Project Waters Stage 1:

Balcony Report

Rev G
19/11/12

AMENDED IN RED
24 JAN 2013

6. Climate and Environment

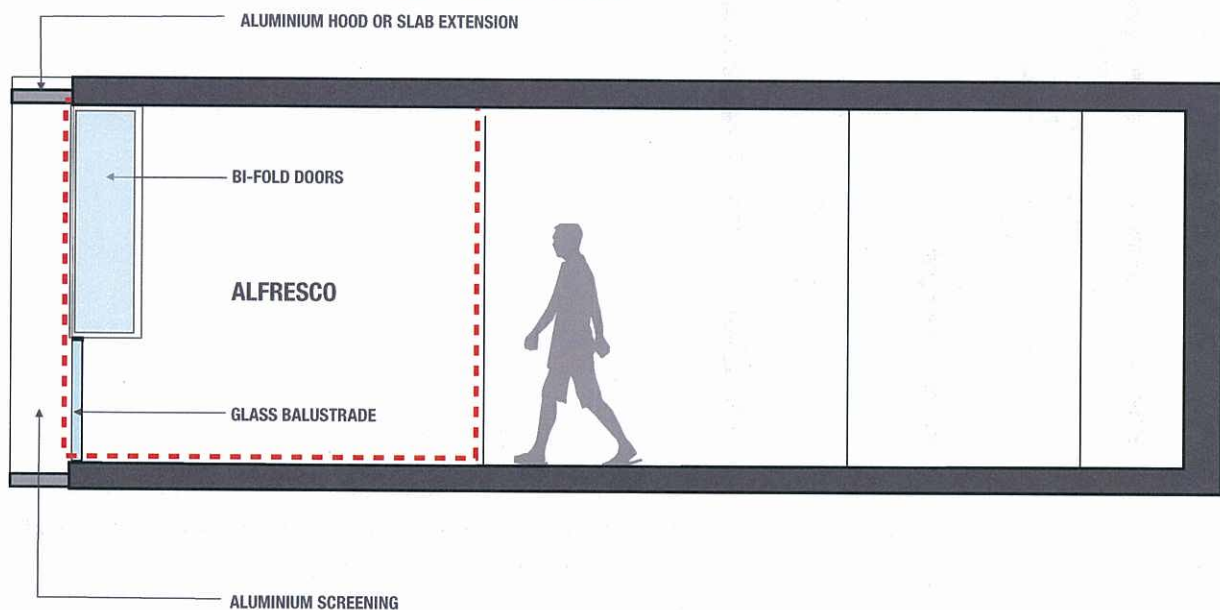
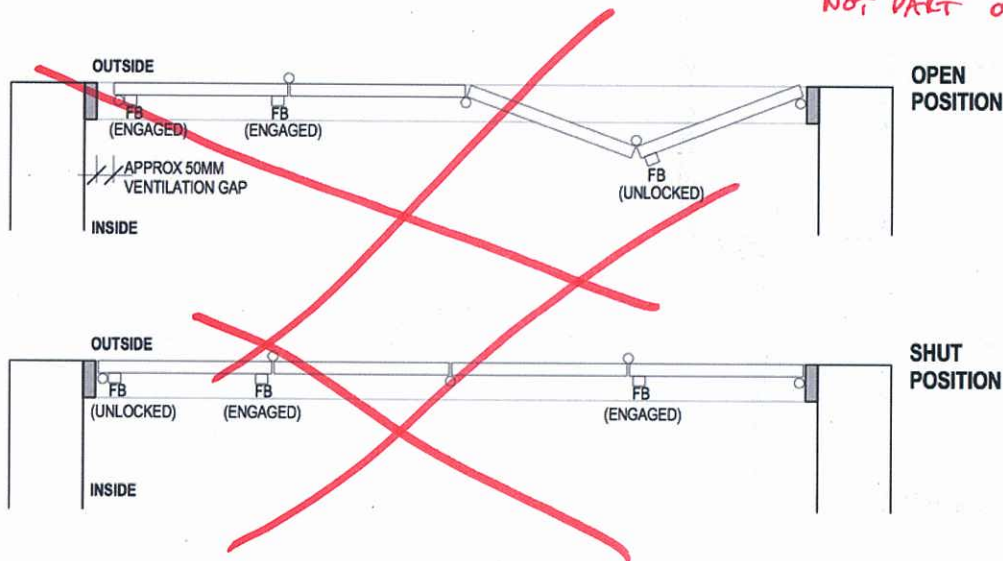
Traditionally the use of deck/balcony space around a dwelling had the effect of setting up a thermal buffer to reduce solar gain. In this scheme it is proposed to use a horizontal metal hoods or slab extensions to increase the effective depth of the adjacent 'Alfresco' space to recreate this buffer. This will be further assisted by the vertical blades and/or horizontal or vertical solid wall panels. Additionally the hoods/slab extensions will provide weather protection from the bifold edge creating a flexible balcony like zone. **THE GLASS BALUSTRADE AND OR WINDOW TO INCLUDE OPENABLE PANELS. WEATHER PROTECTION REQUIRED AS PER CONDITIONS OF APPROVAL.**

~~The bifold windows will also be able to be locked into position by the residents leaving a ventilation gap if so desired.~~

NOT PART OF THIS APPROVAL

7. Balcony Screening

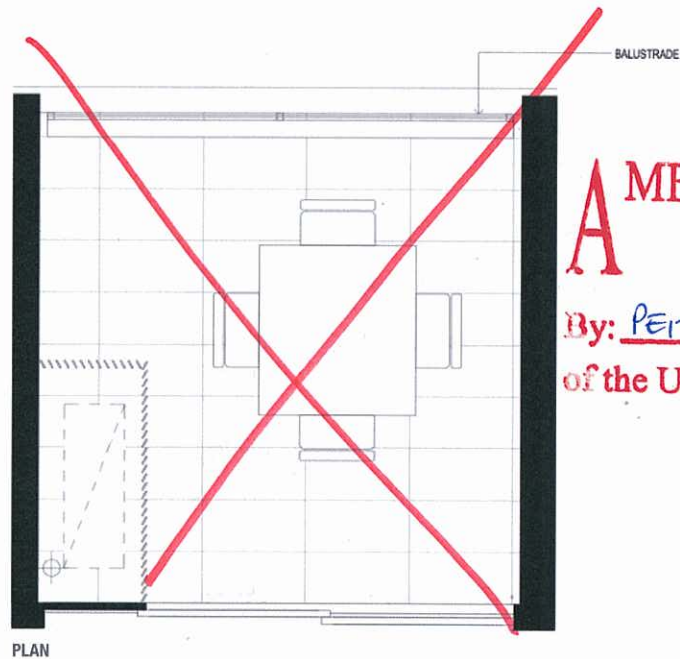
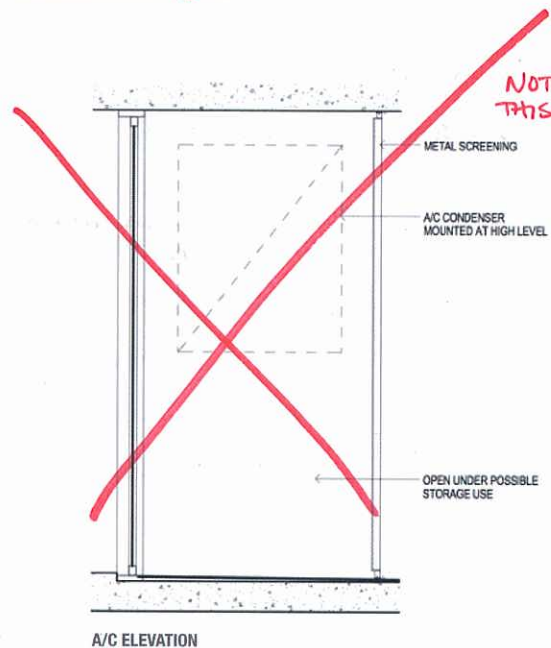
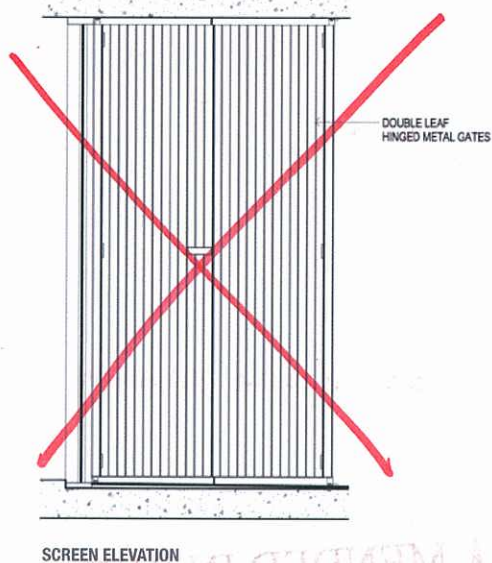
Whilst orientation and screening maximise passive climatic design, acoustic impacts and market demand also require the inclusion of air conditioning to the apartments. *Actual screening design TBA.*

~~The drawings below provide an indication of typical screening and storage arrangement for apartments with a balcony. The air conditioning enclosures provide additional storage space which is considered a significant benefit within this segment of the market.~~

NOT PART OF THIS APPROVAL.
